MODBAR TECHNICAL BULLETIN  
#27  
**AV Tap LED board**

We would like to inform you that the AV tap LED board has been re-designed with more efficient electrical insulation to improve its reliability.

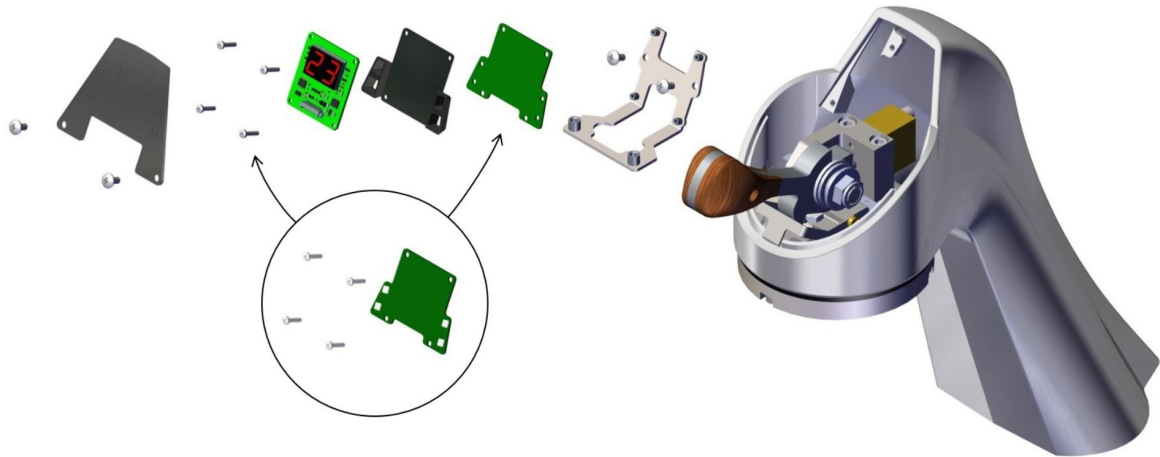
In addition to the new electronic board, the 4 screws which secure it to the bracket have also been substituted with plastic ones.

This modification comes after examining a few issues that have occurred where the LED board stopped working for apparently no reason, giving a "low voltage error" on the module's display. We discovered that the previous LED board E.1.049 was likely to short circuit due to overtightening of its screws, as well as, strong vibrations during transportation or excessive pressure applied onto the display.

Should you experience the same problem, we suggest that you substitute the LED board and screws with the new ones.

This modification takes effect from serial numbers MB001660 and ET000465 (extra tap).

The new board is already available for order from Nuova Ricambi with code E.1.049.R.  
It comes in a kit with its 4 plastic screws, which can also be purchased individually with code I.6.016.
